Docket Item # 7 & 8
BAR CASE #2012-0290 & 0291

BAR Meeting
September 19, 2012

ISSUE: Certificate of Appropriateness for Alterations and Waiver of Rooftop Mechanical Screening Requirement per Section 6-403(B)

LOCATION: 614-618 King Street

STOREFRONT
RENDERING

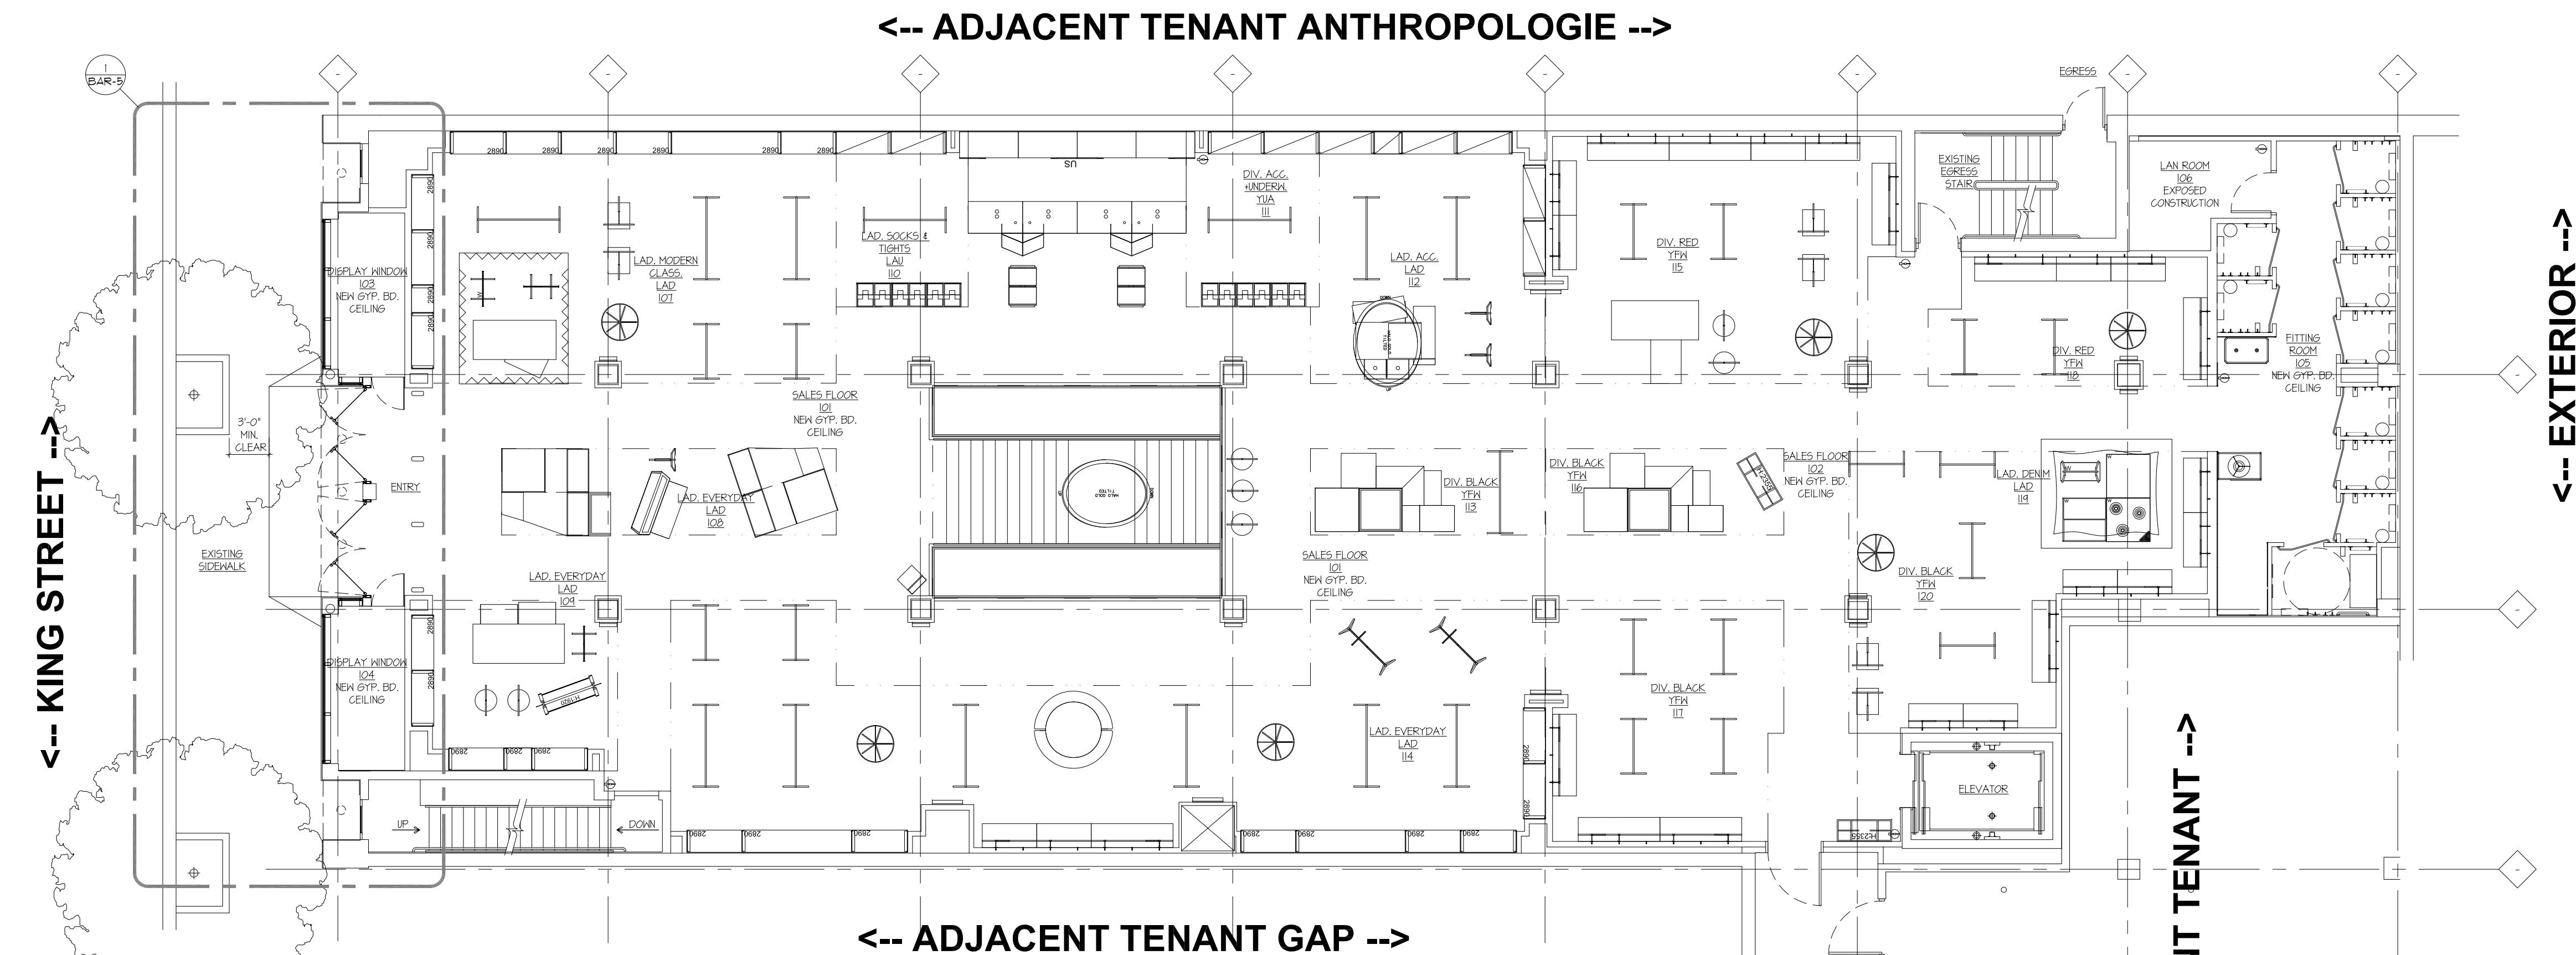
Staff recommends approval of the Certificate of Appropriateness with the condition that the signs are not internally illuminated. If the applicant desires to illuminate the signs they will work with staff on a design which utilizes external illumination using gooseneck or mini-spot lights.

614 King Street is a two-story Colonial Revival building upon which the applicant has chosen a more modern approach for the new storefront that suits the building’s mid-20th century date of construction. The footprint of the existing storefront previously approved by the Board in 1996 will remain intact; however, the existing windows and doors will be replaced. The primary features of the new storefront, which are consistent with storefronts of this period², include the plate glass windows framed with painted metal, recessed metal entry doors, recessed lighting, and back-lit signage.

Staff finds that the proposed alterations to the storefront will not damage or negatively impact any of the existing historic fabric above the first floor. The existing cast stone band above the storefront has already been slightly damaged by holes from previous signage and storefront installations. The proposed painted, metal cornice will be mounted over the band utilizing the existing holes and staff finds that this alteration is a reversible, cosmetic change. All of the proposed storefront alterations at grade are easily reversible. Storefronts are commonly revised in response to changing public taste and retail trends and the proposed alterations will not damage the historic building façade above.

DESCRIPTION: 30" ILLUMINATED FLUSH MOUNT LOGO.

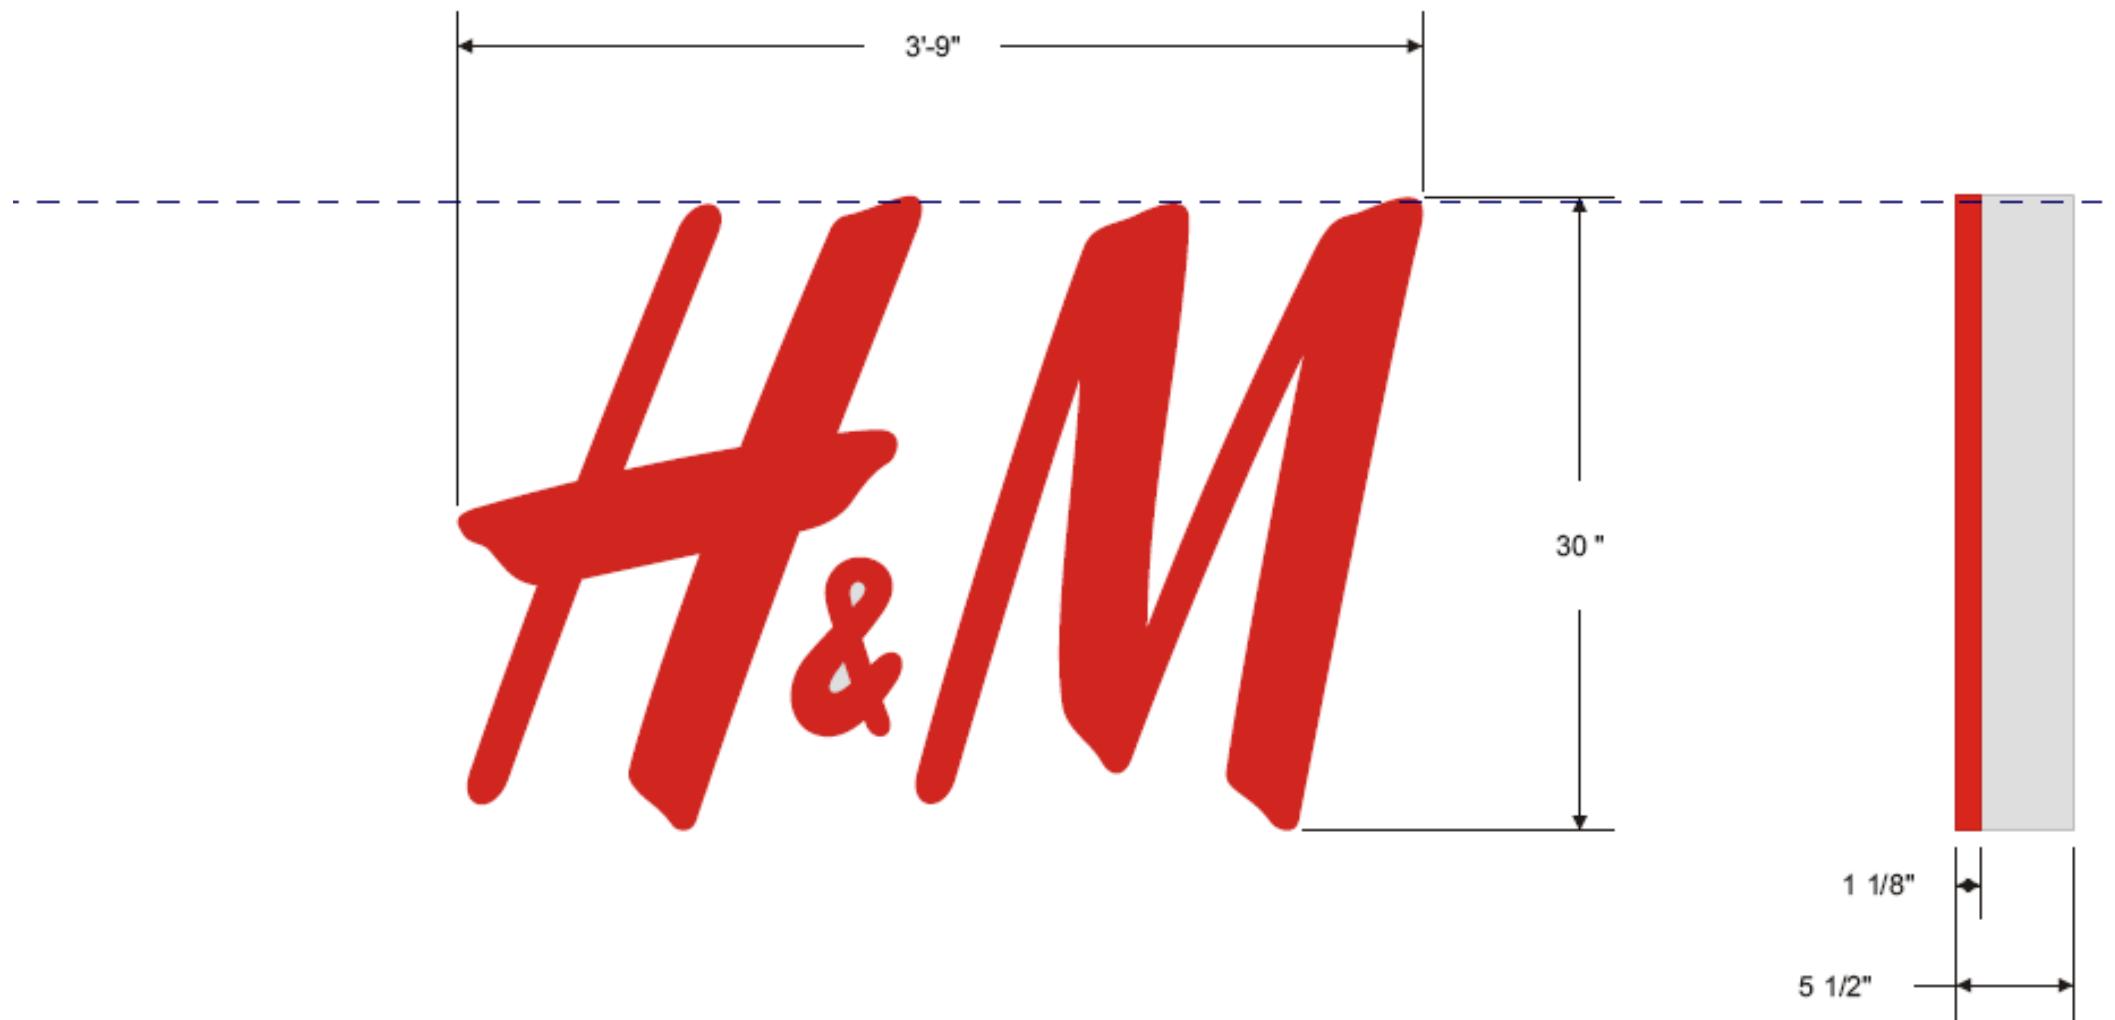
The *Design Guidelines* recommend that one sign per business is generally appropriate. However, the Board has frequently approved more than one sign for a business with a single frontage. The signage typically is a combination of projecting hanging, wall mounted lettering and/or window decals. Due to this large storefront’s location on King Street and the types of signs approved for nearby businesses of similar scale, staff believes that three small signs totaling approx. 22 sq. ft. are appropriate for this business. However, Staff finds the illumination of the signs to be inappropriate, as the Board’s *Design Guidelines* discourage internally illuminated signs. The Board emphasized that internally illuminated and halo illuminated signs were inappropriate on historic buildings during the Burke & Herbert bank case across the street several months ago. Should the Board support external illumination of the signs, Staff recommends minimally visible LED spotlights mounted on conduit arms, similar to those used at the Gap next door and for the previous Restoration Hardware sign lights. The proposed signage is otherwise generally consistent with the *Design Guidelines* in design, material and scale and is appropriate for the architectural character of 614 King Street and this section of the historic district.
